UNITED STATES PATENT AND TRADEMARK OFFICE

APPLICATION NO.	FILING DATE	FIRST NAMED INVENTOR	ATTORNEY DOCKET NO.	CONFIRMATION NO.
10/823,298	04/12/2004	Liping Ren	IR-2390 (2-3	4746
2352	7590	06/01/2005	EXAMINER	
OSTROLENK FABER GERB & SOFFEN 1180 AVENUE OF THE AMERICAS NEW YORK, NY 100368403			PIZARRO CRESPO, MARCOS D	
			ART UNIT	PAPER NUMBER
			2814

Office Action Summary	Application No.	Applicant(s)	
	10/823,298	REN, LIPING	
	Examiner	Art Unit	
	Marcos D. Pizarro-Crespo	2814

DETAILED ACTION

FIG. 19

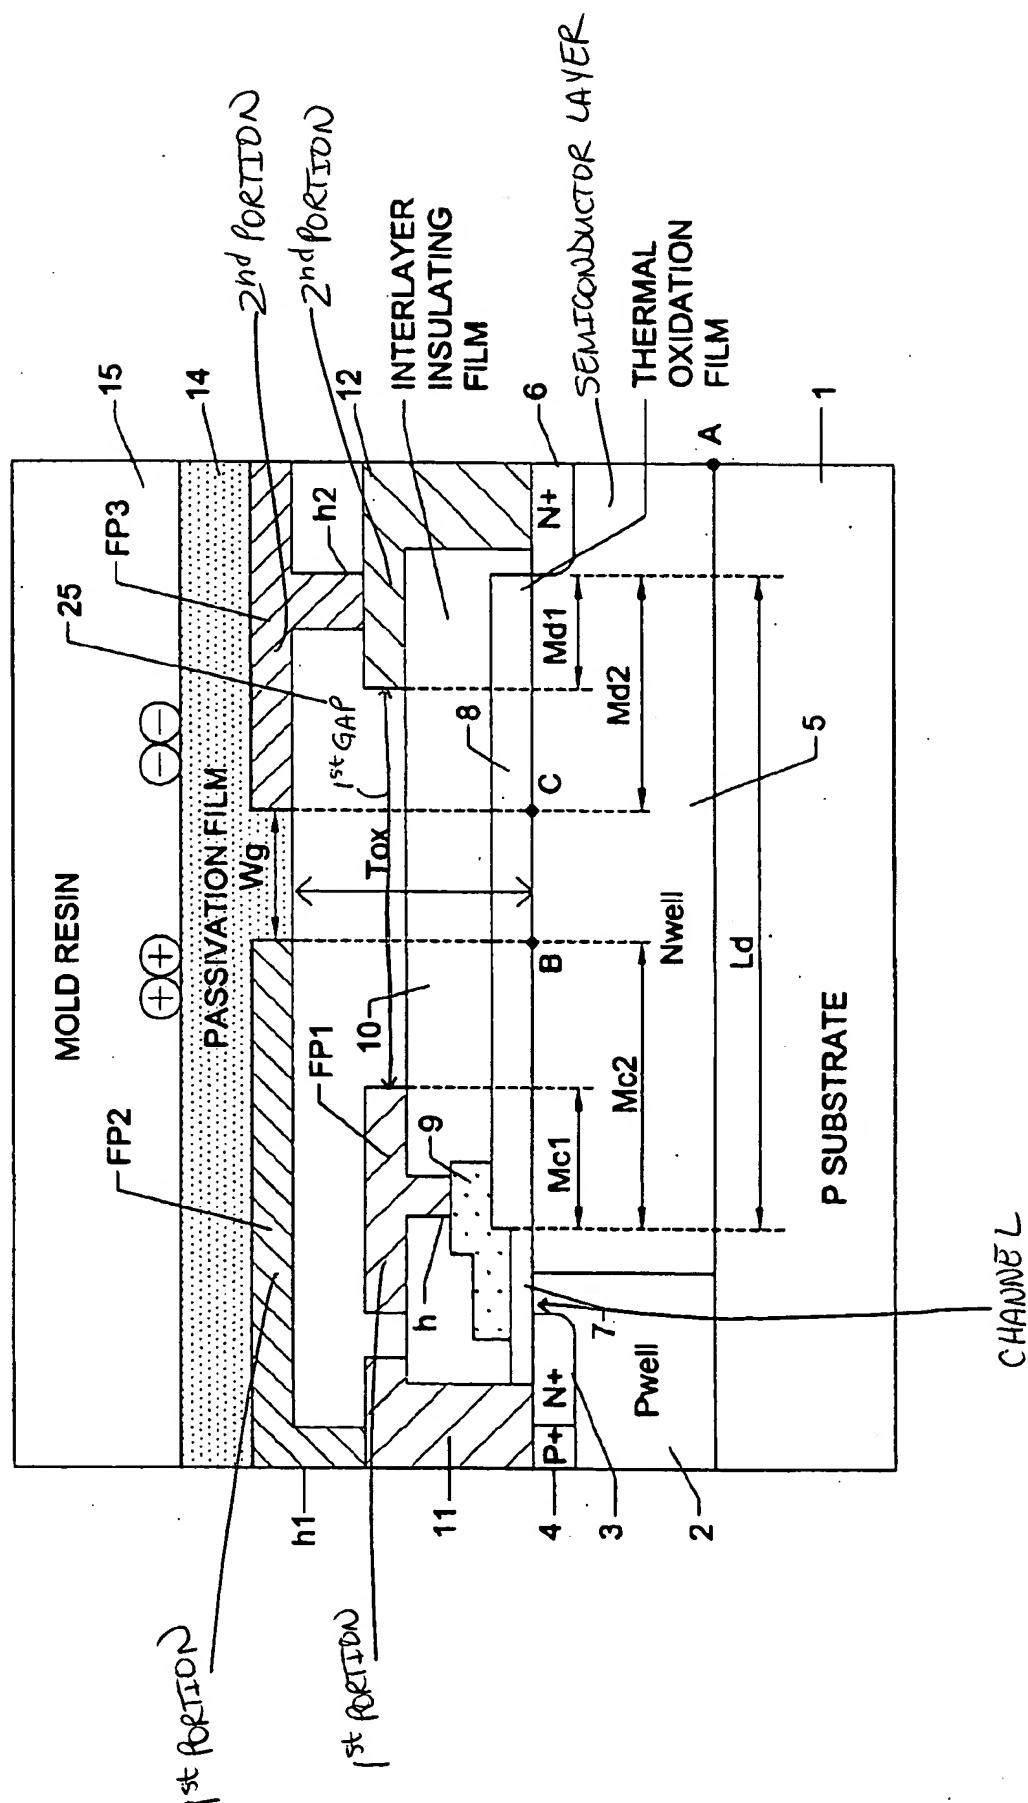
2. Claims 25, 26, 28, and 29 are rejected under 35 U.S.C. 102(e) as being anticipated by Fujishima (US 6740952).
3. Regarding claim 25, Fujishima shows (see, e.g., fig. 19) all aspects of the instant invention including a field plate structure comprising:
 - ✓ A first field plate **9**
 - ✓ A second field plate **FP1** disposed above and spaced from the first field plate
 - ✓ A third field plate **FP2** disposed above and spaced from the second field plate
4. Regarding claim 26, Fujishima shows (see, e.g., attached fig. 19):

- ✓ The second field plate **FP1** including:
 - a first portion
 - a second portion
 - a first gap separating the portions
 - ✓ The third plate **FP2** including:
 - a first portion
 - a second portion
 - a second gap **Wg** separating the portions
 - ✓ The first gap being wider than the second gap **Wg**
5. Regarding claim 28, Fujishima shows (see, e.g., fig. 19):
- ✓ The first portion of the second plate **FP1** is electrically connected to the first plate **9**
 - ✓ The second portion of the second plate **FP1** is electrically connected to the second portion of the third plate **FP2**
6. Regarding claim 29, Fujishima shows (see, e.g., fig. 19):
- ✓ The first plate is insulated from the second plate **FP1** by an insulation layer **10**
 - ✓ The second plate **FP1** is insulated from the third plate **FP2** by another insulation layer **25**

9. Regarding claim 1, Fujishima shows (see, e.g., fig. 19) most aspects of the instant invention including a semiconductor device comprising:

- ✓ A semiconductor substrate **1** of a first conductivity type
- ✓ A semiconductor layer of a second conductivity type formed over the substrate **1**
- ✓ A body region **2** of the first conductivity formed in the semiconductor layer
- ✓ An invertible channel in the body region **2**
- ✓ A source region **3** of the second conductivity type formed in the body region **2** and adjacent to the channel
- ✓ A gate structure formed over the channel region including:
 - a gate electrode **9**
 - a gate insulation layer **7** spacing the gate electrode **9** from the channel
- ✓ A drain region **6** formed in the semiconductor layer
- ✓ A drift region **5** in the semiconductor layer spacing the body region **2** from the drain region **6**
- ✓ A field plate structure disposed over the drift region **5** including:
 - a first insulation layer **8** of a first thickness

- a second insulation layer **10** of a second thickness formed over the first insulation layer **8**
- a third insulation layer **25** of a third thickness
- a first plate **9** disposed over the first insulation layer **8**
- a second plate **FP1** disposed over the second insulation layer **8**
- a third plate **FP2** spaced from the second plate **FP1** by the third insulation layer **25**

10. Regarding claims 2, 4, and 6, Fujishima shows the first **8**, second **10** and third **25** insulation layers comprising an oxide (see, e.g., fig. 19)

13. Regarding claim 4, Fujishima shows the second insulation layer **10** comprising an oxide (see, e.g., fig. 19).

16. Regarding claim 8, Fujishima shows the first field plate **9** extending from the gate electrode (see, e.g., fig. 19)

18. Regarding claim 10, Fujishima shows (see, e.g., fig. 19) the second field plate **FP1** comprising a first portion and a second portion, wherein a gap separates the portions.

20. Regarding claims 12 and 13, Fujishima shows the third field plate **FP2** comprising a first portion and a second portion (see, e.g., fig. 19), wherein a gap of 25 microns separates the portions (see, e.g., col.37/ll.32).

23. Regarding claim 14, Fujishima/Van Zant/Ghandhi shows most aspects of the instant invention (see, e.g., paragraph 9 above). Fujishima also shows the second plate **FP1** including a first portion and a second portion, wherein a gap separates the portions (see, e.g., fig. 19). He, however, fails to specify the portions to be annular portions disposed around the drain region **6**. Noda, on the other hand, teaches (see, e.g., fig. 1) that annular plates formed concentrically around the drain diffusion region of Fujishima would improve the breakdown properties of the device (see, e.g., Noda/col.14/ll.20-22). Ranjan elaborates by teaching that the series of plates in Noda reduce the tendency to concentrate high electric fields near the surface of the device thereby improving its breakdown voltage (see, e.g., Ranjan/col.5/ll.52-56).

25. Regarding claim 16, Fujishima (see, e.g., fig. 19) shows the third plate including a first portion and a second portion, wherein a gap separates the portions. He,

- ✓ The second plate **FP1** including (see, e.g., fig. 19):
 - a first portion
 - a second portion
 - a first gap separating the portions
- ✓ The third plate **FP2** including (see, e.g., fig. 19):
 - a first portion

- a second portion
 - a second gap **Wg** separating the portions
- ✓ The first gap being wider than the second gap **Wg** (see, e.g., fig. 19)

28. Regarding claim 19, Fujishima shows that when the first gap is 25 microns, the second gap is 48 microns (see, e.g., fig. 19, col.37/ll.32, and col.39/ll.13-16), instead of the claimed second gap of 45 microns. See also the comments stated above in paragraphs 11 and 12 with respect to the differences between the claimed dimensions and those of the prior art, which are considered repeated here.

29. Regarding claim 20, Fujishima shows the first plate **9** terminating below the first portion of the second plate **FP1** (see, e.g., fig. 19).

30. Regarding claim 21, Fujishima shows the second portion of the second field plate **FP1** is electrically connected to the drain region **6** and to the second portion of the third plate **FP2** (see, e.g., fig. 19).

31. Regarding claim 22, Fujishima shows the first portion of the second plate **FP1** is electrically connected to the first plate **9** (see, e.g., fig. 19).

32. Regarding claim 23, Fujishima shows the first portion of the third plate **FP2** is electrically connected to the source region **3** (see, e.g., fig. 19).
